FINAL MONITORING REPORT
2021 (Year 3)

HERON STREAM AND WETLAND MITIGATION SITE

Response to Monitoring Year 2 (2022) DMS Comments

Heron Stream and Wetland Mitigation Site (DMS #100014)
Cape Fear River Basin 03030002, Alamance County
Contract No. 7192

Site	Heron
Watershed:	Cape Fear, 0303002
XS ID	UT 3, XS - 9, Pool
Feature	Pool
Date:	2/16/2021
Field Crew:	Perkinson, Adams, Lawson, Harris

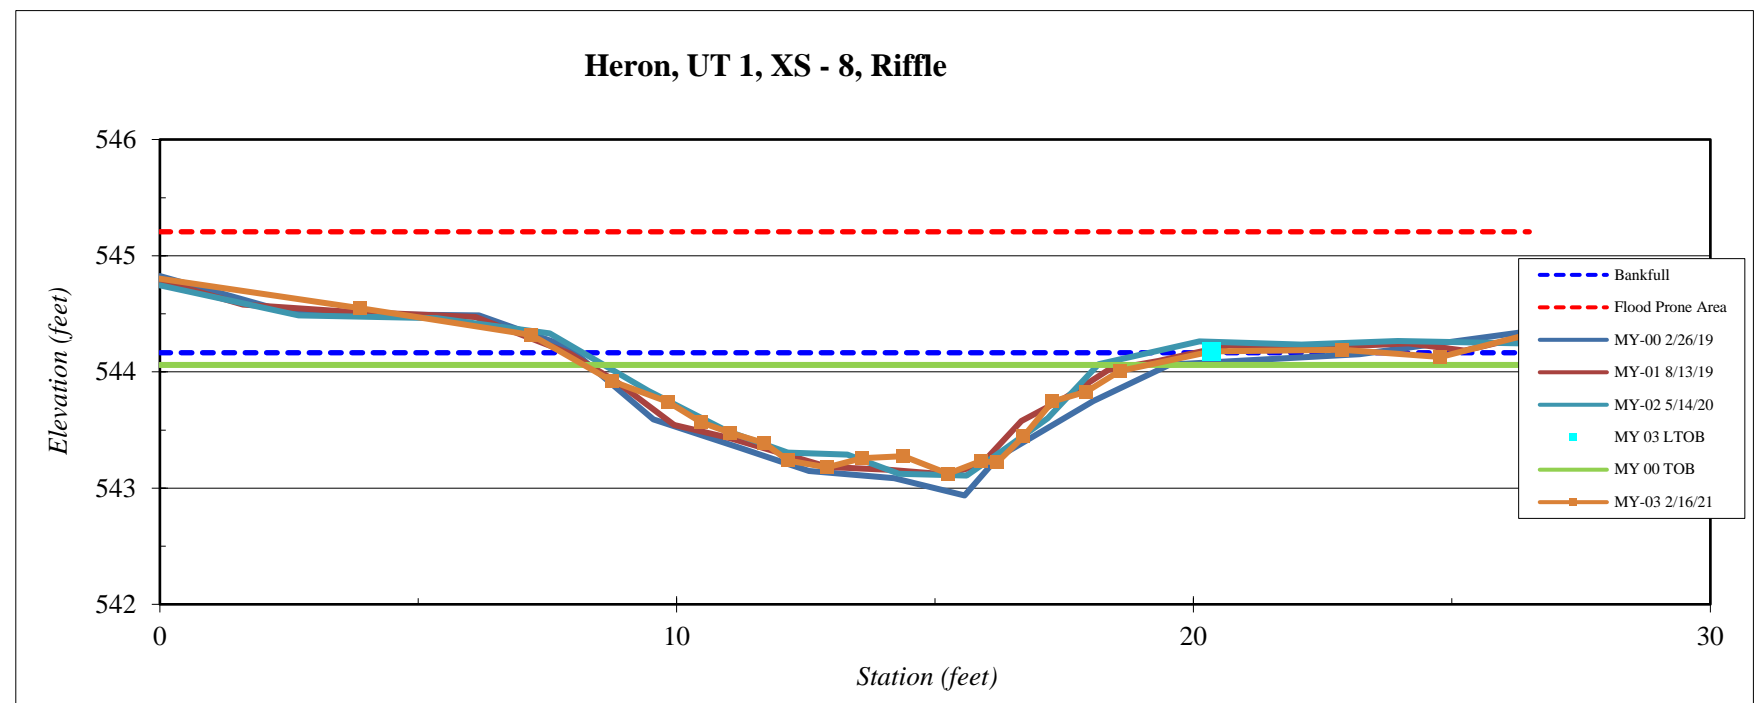
An error in processing was corrected on cross-section 33 riffle.
6. Cross section 9 (pool) shows BHR at 1.29 but there don't appear to be signs of degradation (it looks like aggradation between baseline and MY1). Check that number and revise if necessary and/or explain this in the response.

This cross-section aggraded between MY0 and MY1 but appears to have stabilized since. There was an error in processing (the wrong TOB elevation was used). This has been corrected, resulting in a BHR of <1.

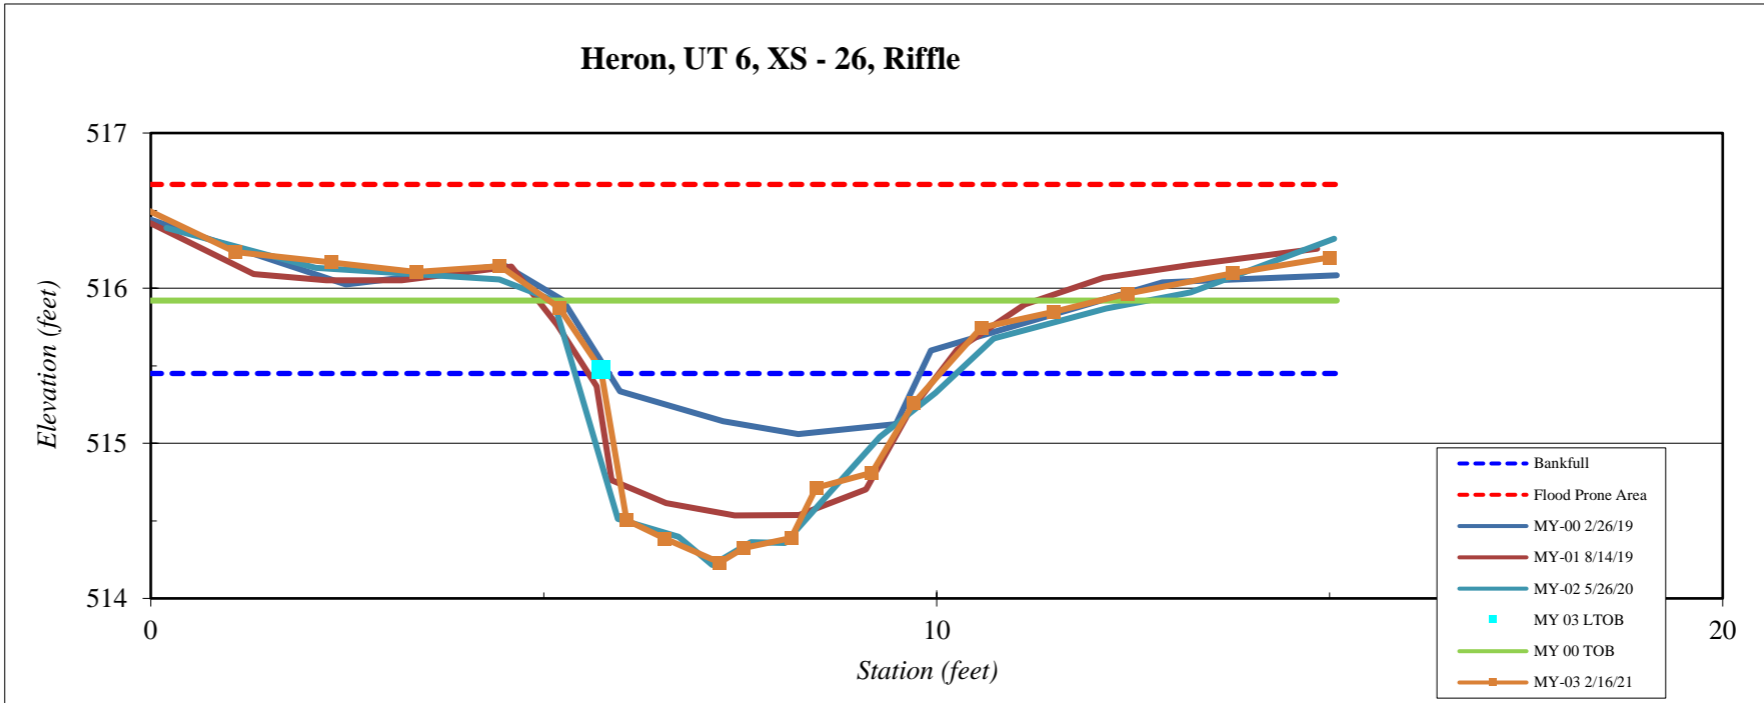
7. XS-26 and XS-27 footnote states that riffle degradation and pool deposition is natural, but DMS does not agree. Some aggradation is expected from construction on riffles, and degradation in pools as a general statement. It would be better to explain what RS thinks occurred here and/or why.

The degradation in XS-26 is likely a result of upstream land-use causing more direct, flashy flows during heavy rain events prior to the streambed fully settling post-construction. The majority of the degradation occurred between MY0 and MY1, and MY2 and MY3 data are virtually the same. This indicates stability, although RS will continue to monitor this reach for additional degradation through the remainder of the monitoring period. XS-27 aggradation occurred shortly after construction, likely from fines being flushed out of riffle bed material upstream and settling in this lower energy reach of stream. Virtually no additional aggradation has occurred since MY1, and the pool appears to have stabilized. The notes on these cross-sections were revised for clarity.

Note: Riffle degradation is likely a result of direct, flashy flows from upstream land-use just after construction. It appears to have stabilized during years 2-3.

Heron Groundwater Gauge 1 Year 3 (2021 Data)

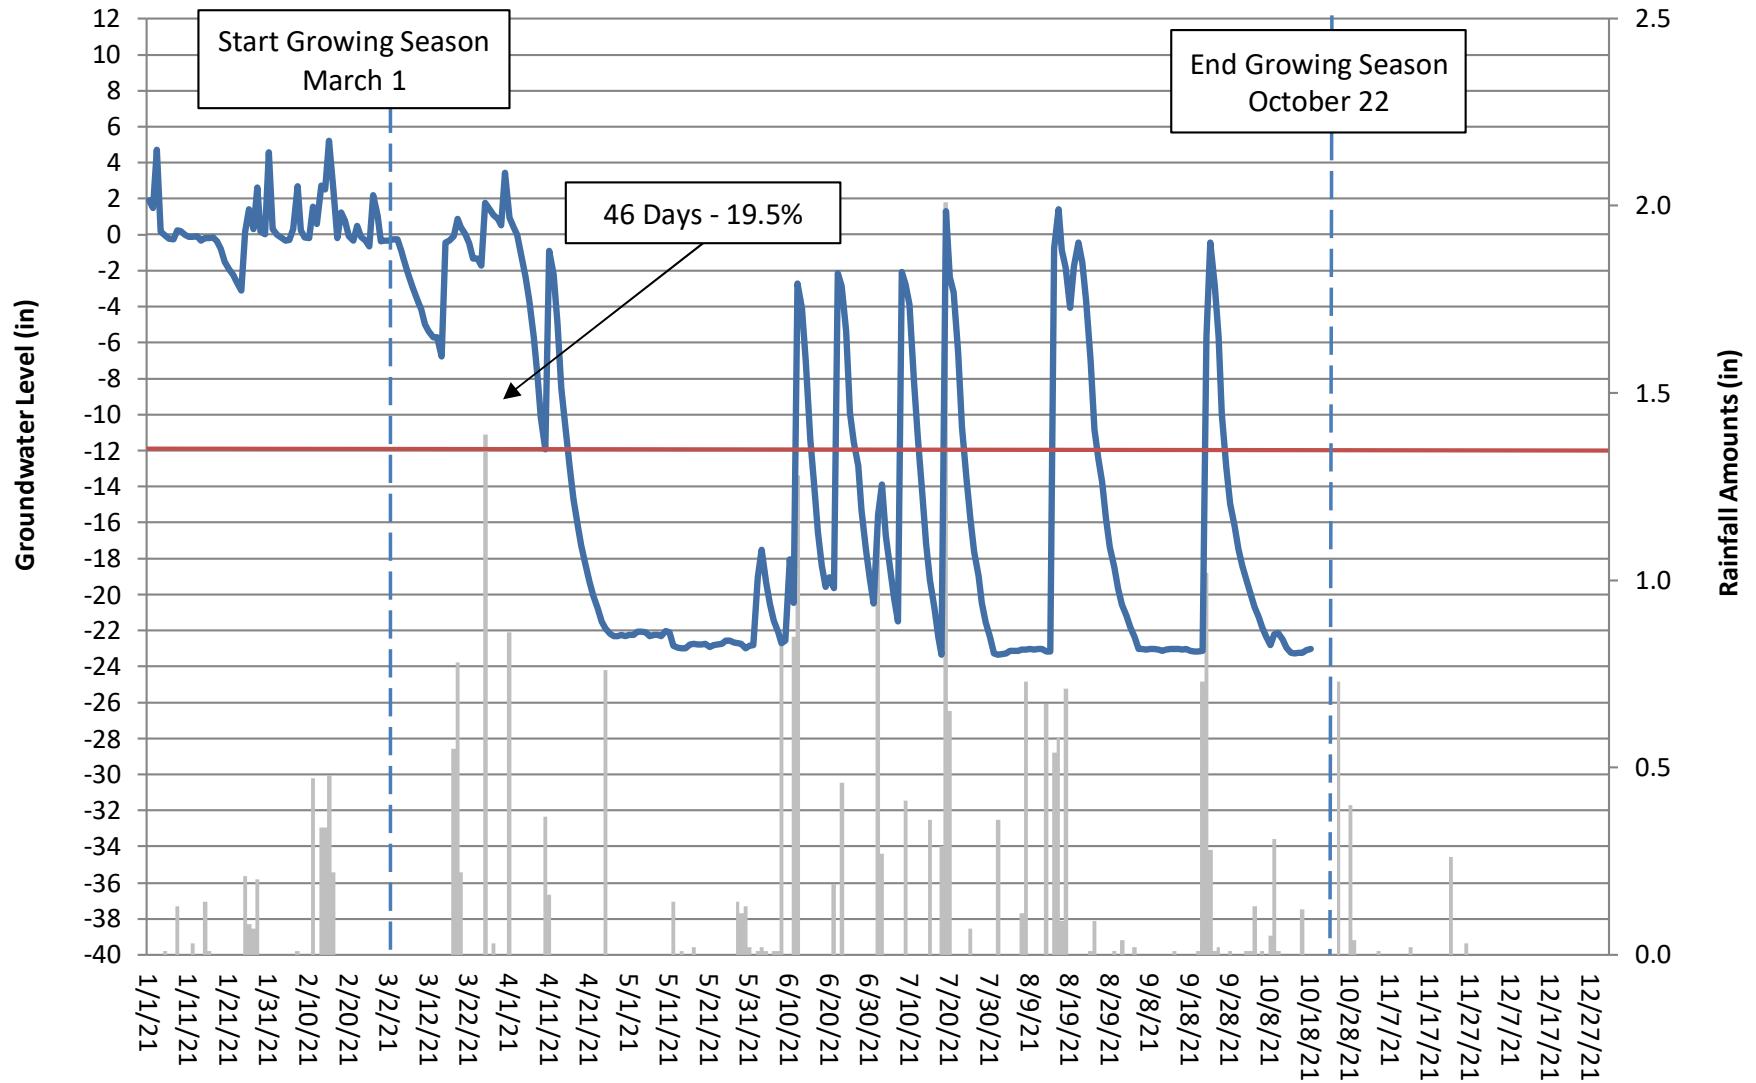
8. GW gage 1 is missing the label that includes # continuous days and % hydroperiod like the other graphs.

The label was added to the graph.
